**LOCAL HISTORIC DISTRICT:** Plaza Midwood

**PROPERTY ADDRESS:** 2037 The Plaza

**SUMMARY OF REQUEST:** Addition - Fenestration and material changes, site improvements

# Renovation of 2037 The Plaza Revision 11-2014

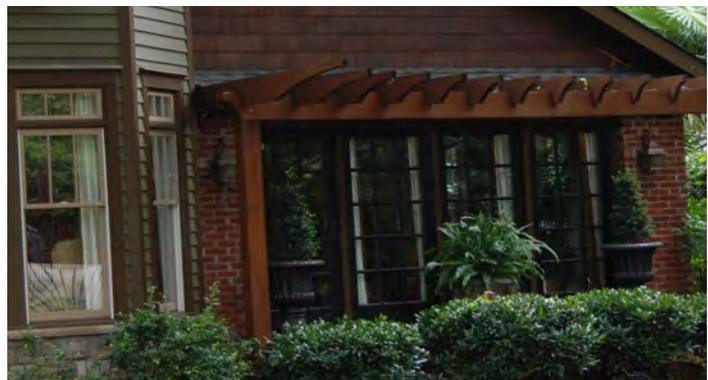
Current siding to be replaced with cedar siding; smooth face 5/8" thick beveled cedar. No cedar shake addition. No mullions will be added to the window glass .

Window trim to be enhanced to 6.5 inch header with 1 3/8 panel mold applied to the top edge, brick mold 3 1/2 flat stock, and traditional sub-sill and apron. Sample below.

Existing parging on foundation to be repaired and painted a darker colour.

Porch to be cleaned and repaired; brick steps to be replaced with only one type of red brick.

28 " Rafter tail design to be added to the back of the house over patio.
